## RESPONSE TO THE REFEREE REPORT by Francesco Serinaldi

**Response to the Review on**  
**“Assessment of extreme flood events in changing climate for a long-term planning of socio-economic infrastructure in the Russian Arctic”**  
**by E. Shevnina et al.**

# Assessment of extreme flood events in changing climate for a long-term planning of socio-economic infrastructure in the Russian Arctic

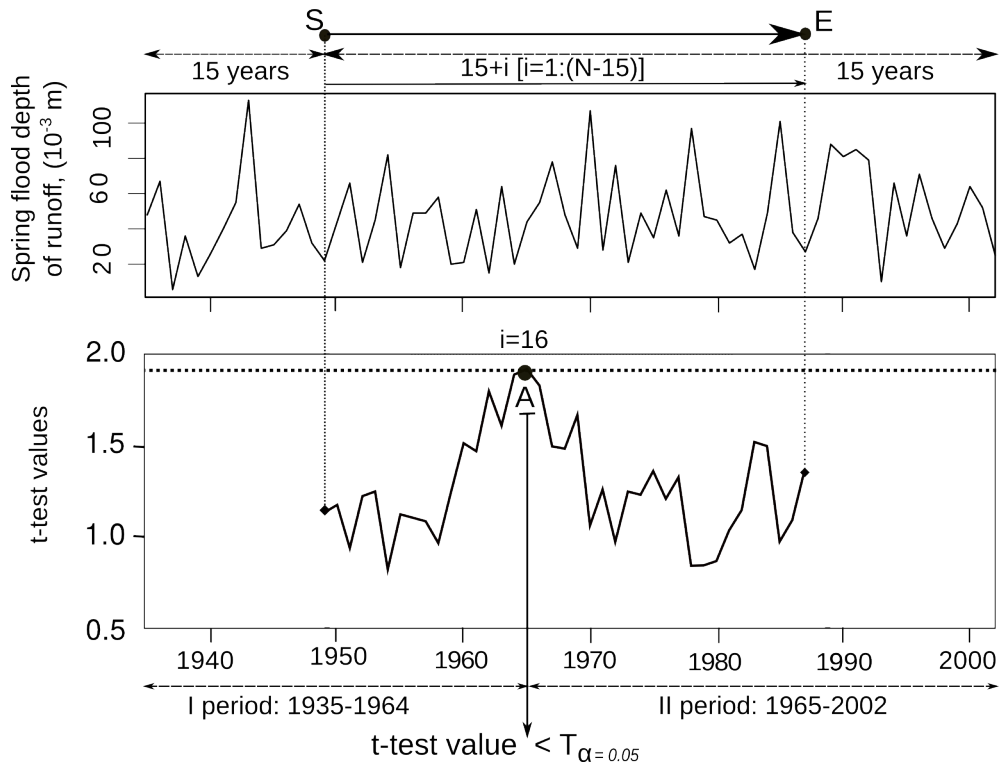
Figure 2. The explanation for points “A”, “S”, “E” and “i” should be added.  
Our response: the comments to the figure were corrected.

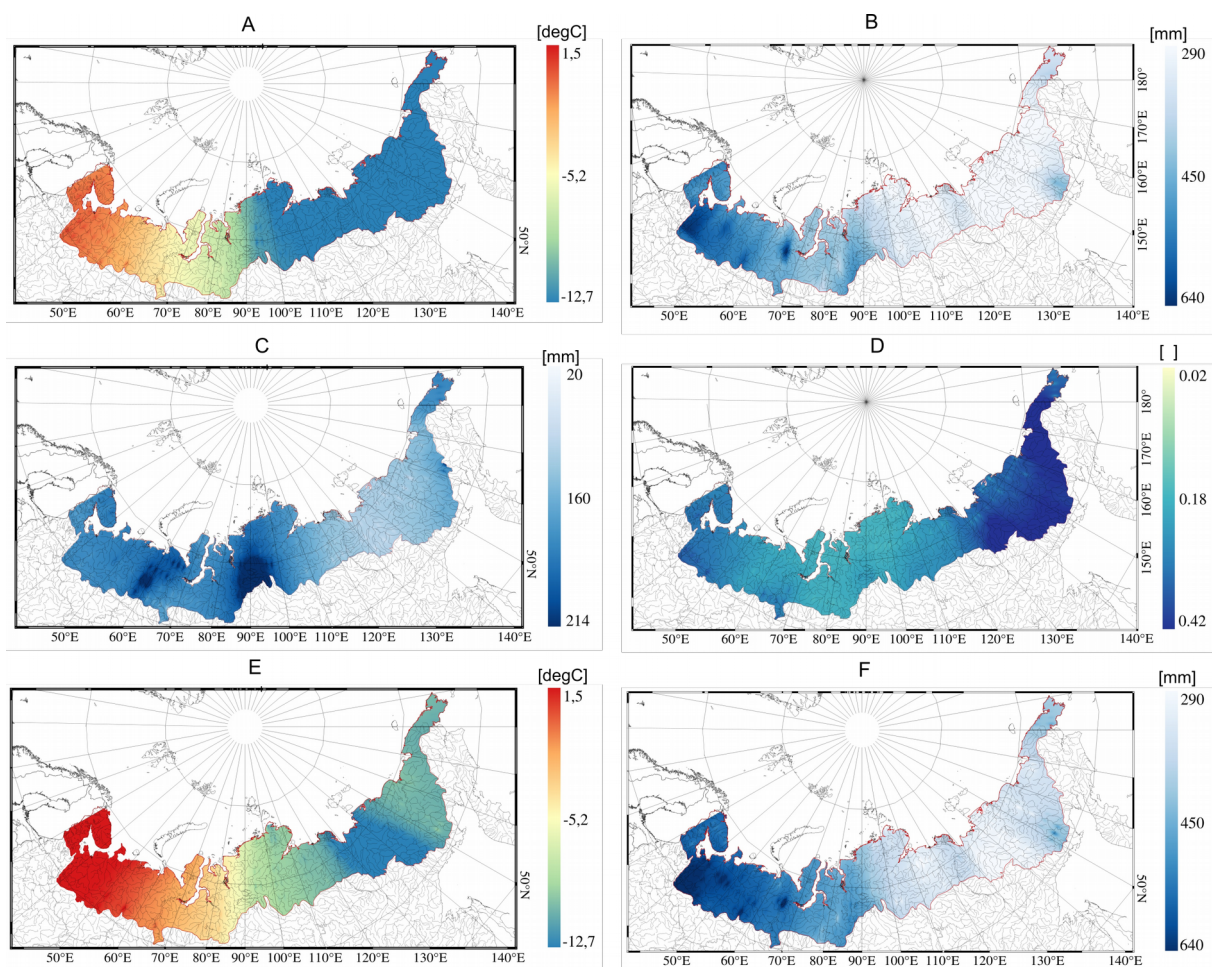
Figure 4. Dimensions for each scale should be added because they are different.  
Our response: the figure was corrected.

**Figure 5.** The changes of the mean values (bars) and coefficients of variation (squares) of the spring flood depth of runoff expected for the regions of the Russian Arctic for the period 2010–2039.

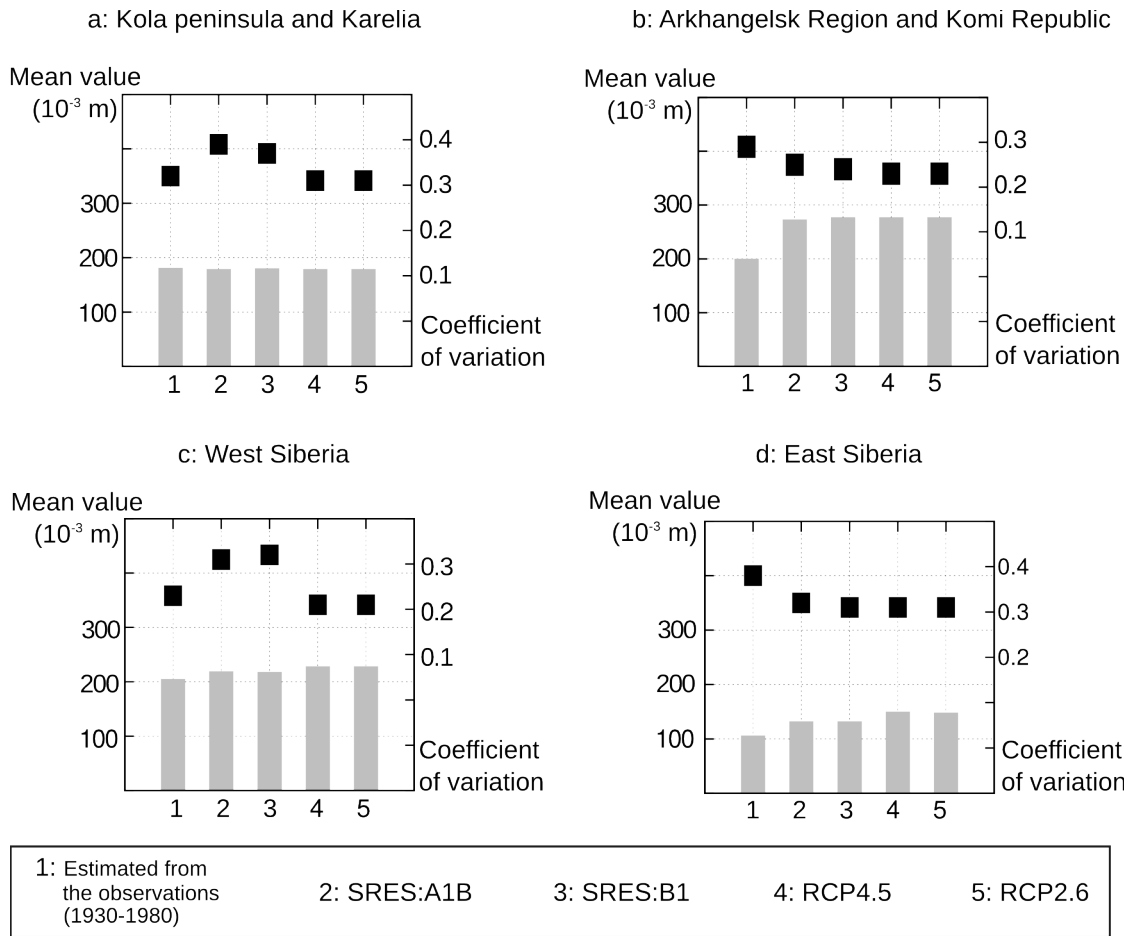
Several regions in the Russian Arctic noticed in the text (Figure 5, for example), list of considered rivers presented in the table 1 and 2. But the region specific had not been hydrological / hydrographically explained (how the authors sort them out?).

Our response: The Russian Arctic was divided into four parts to develop the specific parameterization schemes since the uniform scheme provides less effective results. The principles of the regions division was based on the dominant geology, geomorphology and permafrost features and were presented in Shevnina (2012).

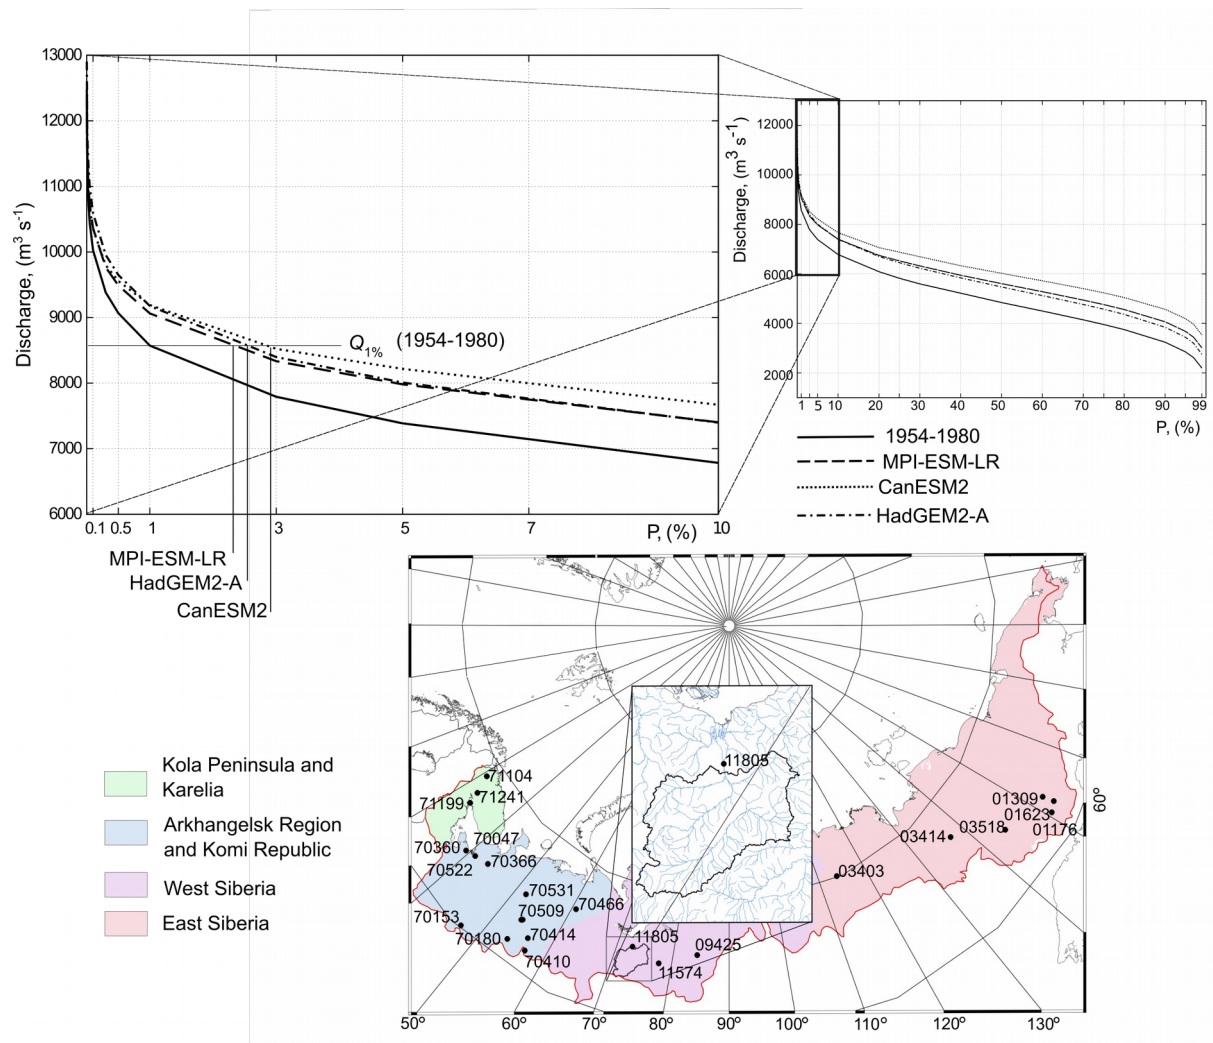
The regions consider different quantity of measured points (Figure 8)? There are 3 points for Kola region, 10 – for Arkhangelsk and Komi, 3 – for West Siberia, and 6 – for a huge East Siberia. Does the East Siberia have enough density or not in your opinion?

Our response: the points in Fig. 8 present the gauges used for the model validation. These gauges were selected from other (76 gauges) since two periods with statistically significant difference in the mean values in the runoff timeseries were defined (see Section 2.2). The amount of gauges is limited especially in Siberia, but these data were not used to calculate the projected runoff's statistics.
